HISTORIC AND DESIGN REVIEW COMMISSION

HDRC CASE NO: 2022-304
ADDRESS: 802 N PINE ST
LEGAL DESCRIPTION: NCB 1656 BLK D LOT W 152.4 FT OF S 23.87 OF 7 & W 152.4 FT OF 8
ZONING: R-5, H
CITY COUNCIL DIST.: 2
HIST. DIST. NAME: Dignowity Hill
APPLICANT: Eva M. Saunders/MAE REAL ESTATE HOLDINGS LLC
OWNER: Eva M. Saunders/MAE REAL ESTATE HOLDINGS LLC
TYPE OF WORK: Modifications to a rear accessory structure, addition to a rear accessory structure
APPLICATION RECEIVED: May 12, 2022
60-DAY REVIEW: Not applicable due to City Council Emergency Orders
CASE MANAGER: Jessica Anderson

The applicant requests a Certificate of Appropriateness for approval to complete the following scopes of work on the rear detached accessory structure:

1 FLOOR PLAN
3/8" = 1'-0"

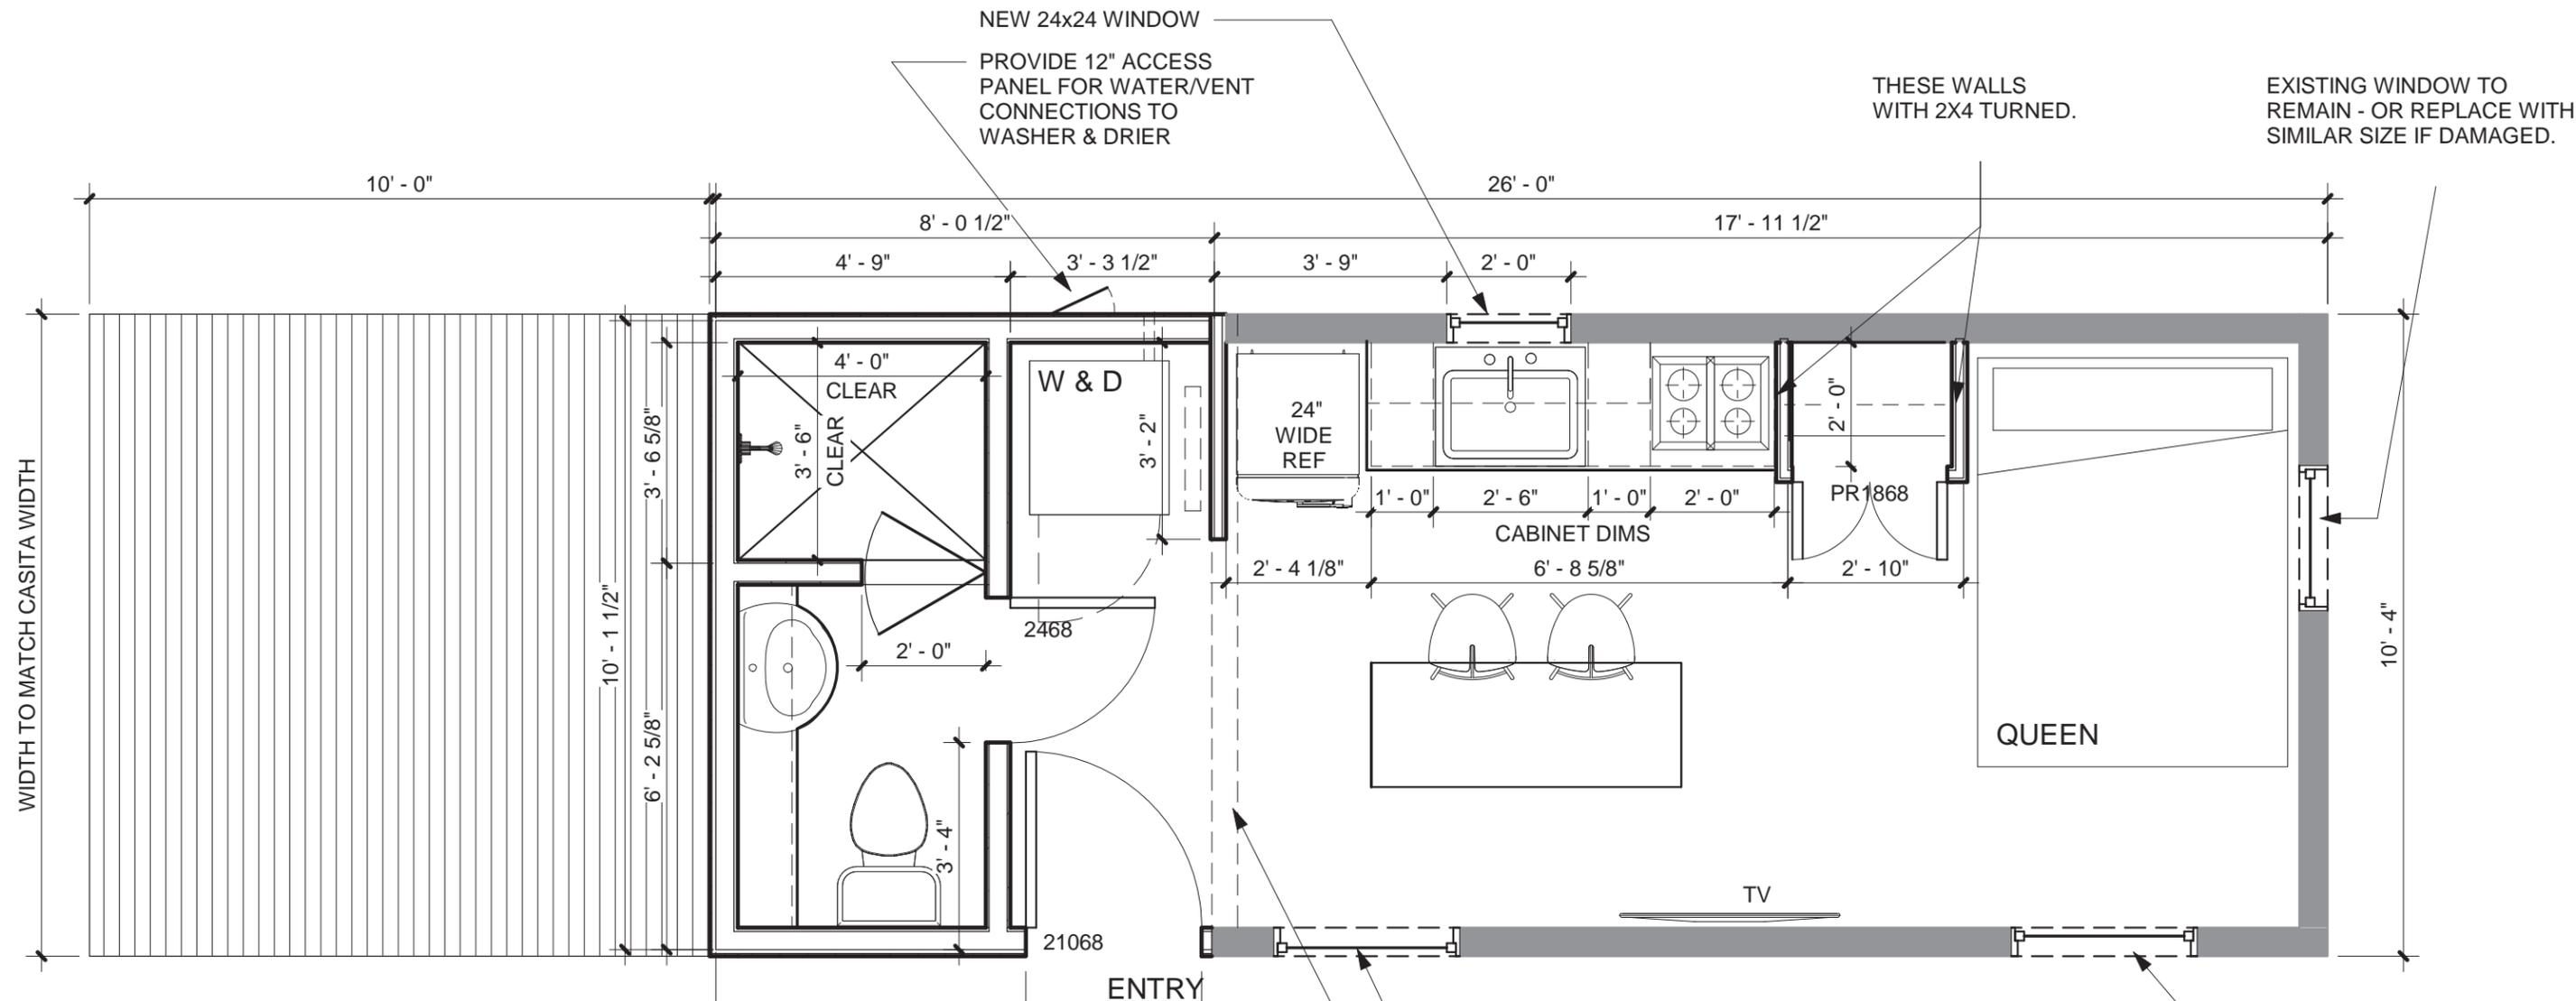
- g. ADDITION (Accessory): The applicant proposes to construct an 80-square-foot addition to the accessory structure, increasing the size from 180 square feet to 260 square feet. The addition includes a door on the south elevation, installed just west of its historic location. The applicant proposes adding a 12"x48" window to the west end of the addition. Staff finds the addition, including the proposed fenestration to the west end, generally appropriate.

Staff recommends approval of item 7, construction of an 80-square-foot addition, based on finding g, with the following stipulation:

- i. That the window proposed for the west elevation conform to the Standard Specifications for Windows in Additions and New Construction, specifically that it relates to the windows on the primary structure in style and dimensions and is wood sash or aluminum-clad wood sash.
